SUBJECT: Savannah River Site's Responses to the Regulatory Comments on the 2021 Annual Comprehensive TNX Area Groundwater Monitoring and Remedial Action Effectiveness Interim Report (U) (SRNS-RP-2022-00627, Revision 0, August 2022) SEMS Numbers: 21, 29

**SRS Responses to SCDHEC Comments on the
2021 Annual Comprehensive TNX Area Groundwater Monitoring and Remedial Action
Effectiveness Interim Report (U), SEMS Number 21, 29, SRNS-RP-2022-00627, Revision 0,
Dated August 2022, Savannah River Site, Aiken, South Carolina**

**SRS Responses to EPA Comments on the
2021 Annual Comprehensive TNX Area Groundwater Monitoring and Remedial Action
Effectiveness Interim Report (U), SEMS Number 21, 29, SRNS-RP-2022-00627, Revision 0, Dated
August 2022, Savannah River Site, Aiken, South Carolina**

Attachment 1. Location of TNX Waste Units

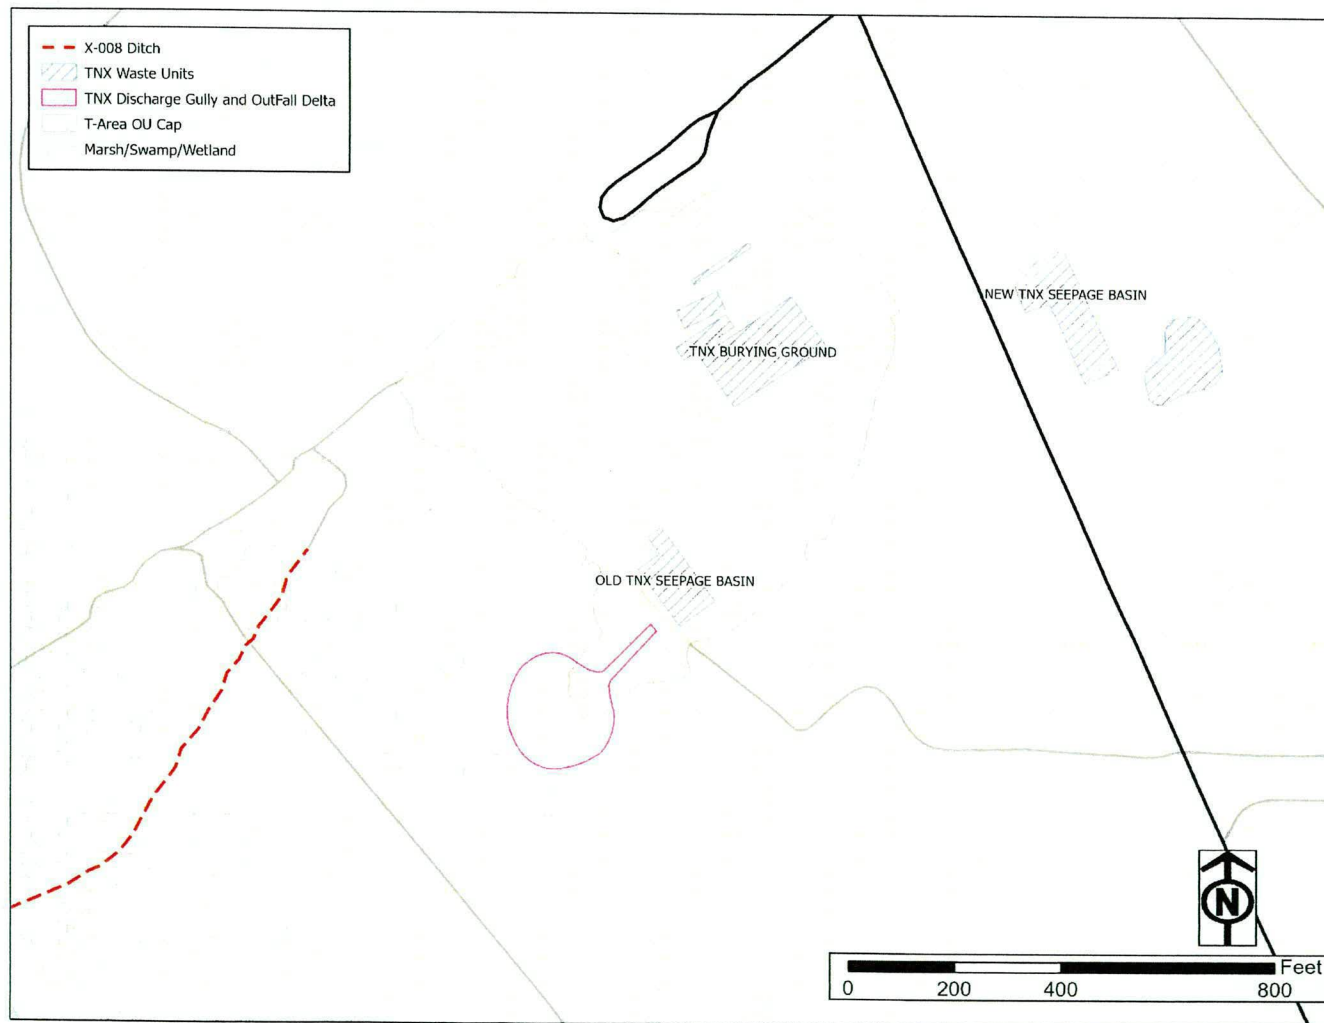
2. Section 3.5, Radiologically Contaminated Groundwater, page 12. Please include a figure that shows the locations of the two localized areas where groundwater monitoring wells indicate exceedances of MCLs for radionuclides as discussed in this section.

A new figure will be added to the 2022 annual report and appropriately referenced in Section 3.5. See Attachment 1 for an example of the new figure. The figure will depict the TNX OU with all waste units clearly defined. In addition to adding the new figure, the following text will be revised for the 2022 annual report: “The two areas are ~~downgradient~~southwest of the TBG and in the wetlands ~~downgradient~~southwest of the OTSB, near the TNX OD.” No change to the current report is proposed.

Attachment 3. Diagram of Collecting a Soil Vapor Sample from an SVE Well using a Vacuum Pump

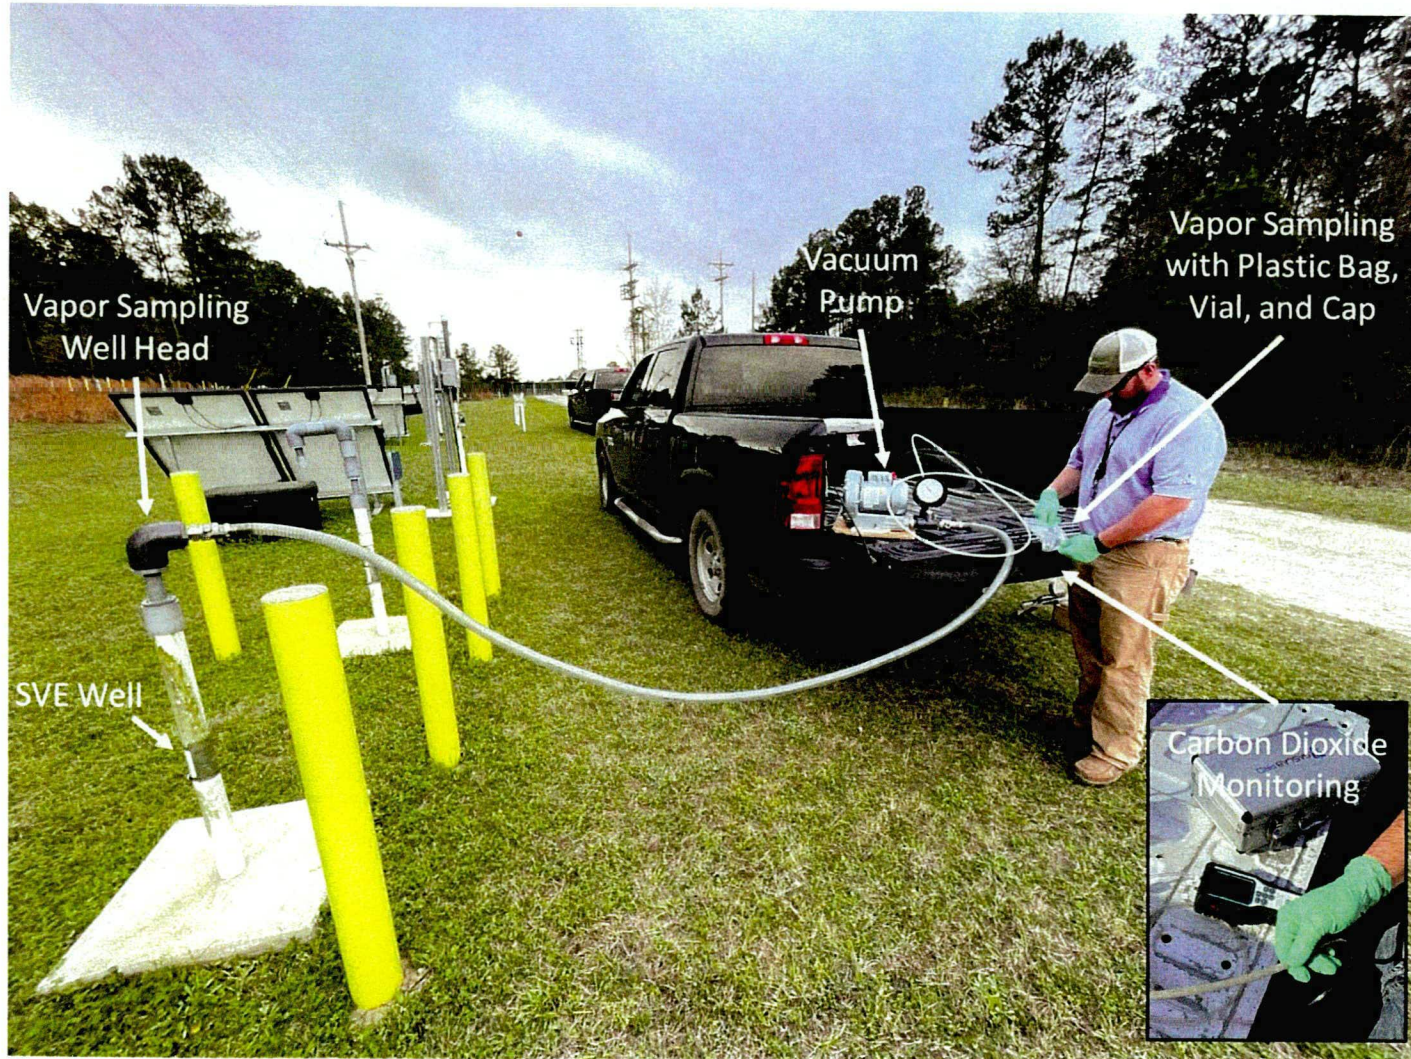
a. It is unclear how the sample delivery line will be connected to each SVE well head, and how the sampling train will be laid out regarding fittings, connections to the pump and sampling container, etc. Please describe the general soil vapor sampling train layout and how this will be connected to the well head to ensure a leak-free connection.

Attachment 3 represents the configuration between the SVE well, the vacuum pump, and the sampler when a vacuum pump is used to sample the SVE wells. Attachment 4 represents the configuration between the SVE well, MicroBlower™, and sample port when a vapor sample is collected from a MicroBlower™.

Attachment 1. Revised Figure A-21

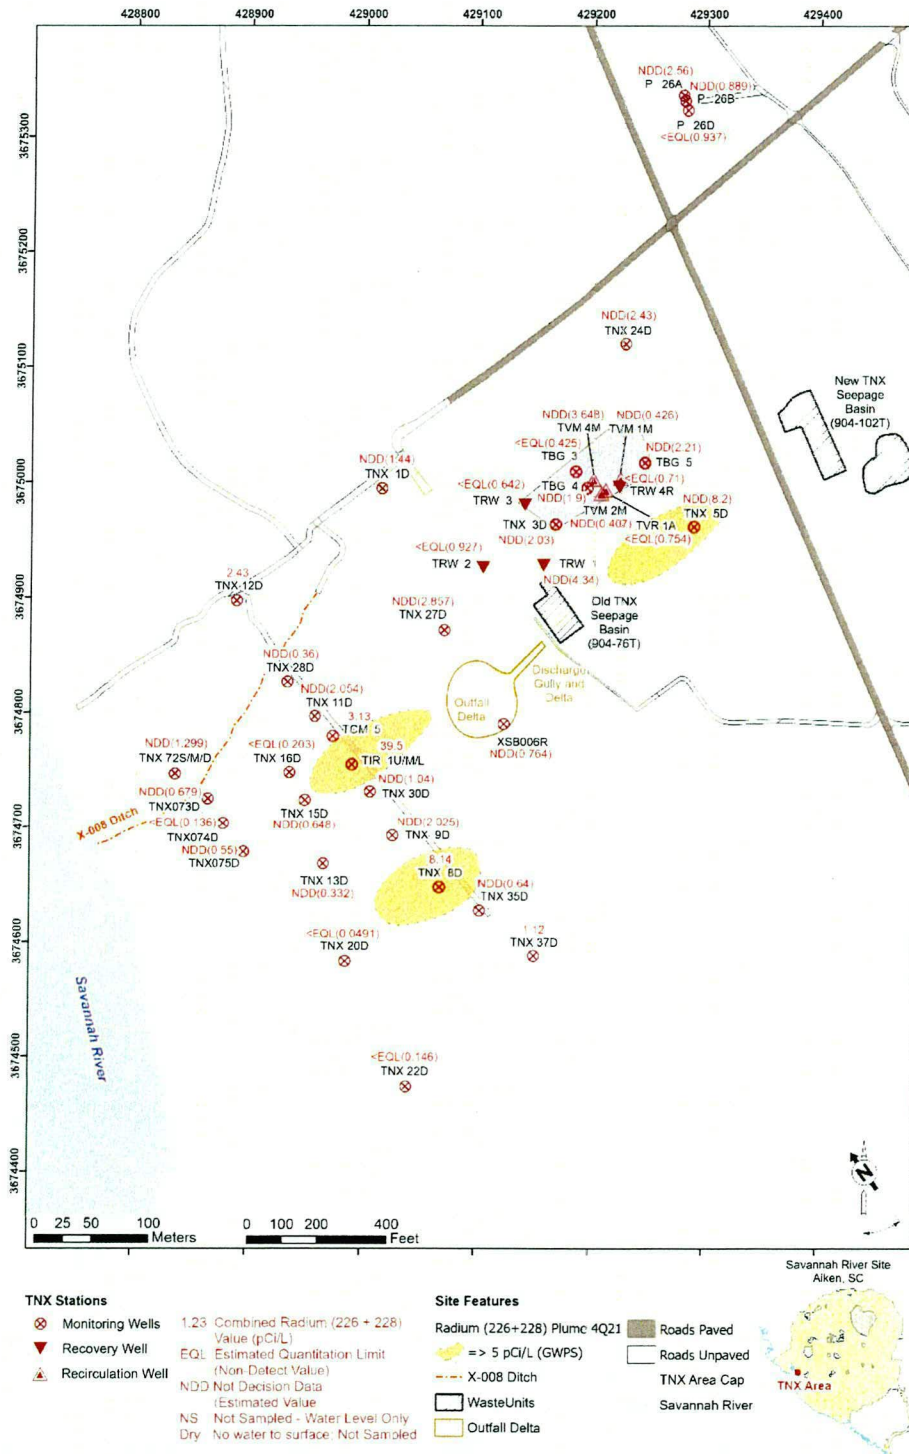
3. The exceedances of the combined radium maximum contaminant level (MCL; 5 picocuries per liter [pCi/L]) are not consistently presented in the Annual Report. Section 5.4 (Analytical Results) notes that the combined radium concentrations exceeded the MCL at wells TNX 5D and TIR 1U; however, Figure A-21 (TNX Area Combined Ra-226/228 Activity in Groundwater, 4Q2021) does not show a plume at the location of TNX 5D. Additionally, Table B-2 (Groundwater Monitoring Results for TNX Area Wells, Fourth Quarter, 2021) does not indicate that the combined radium results at wells TNX 5D and TIR 1U (i.e., 8.2 pCi/L and 7.539 pCi/L, respectively) exceed the MCL. Figure A-21 notes that the result is “NDD” defined as Not Decision Data in the figure legend, and Table B-2 indicates the value is estimated. However, according to Appendix C, (Data Review Key, page C-7 of C-12) the NDD result is still useable even if it is an estimated value. Please revise Figure A-21 and Table B-2 to note these exceedances of the combined radium MCL at wells TNX 5D and TIR 1U.

For Figure A-21, there should have been a greater than 5 pCi/L contour encircling TNX 5D. Figure A-21 has been revised and included in these comment responses as Attachment 1. No change to the current report is proposed.
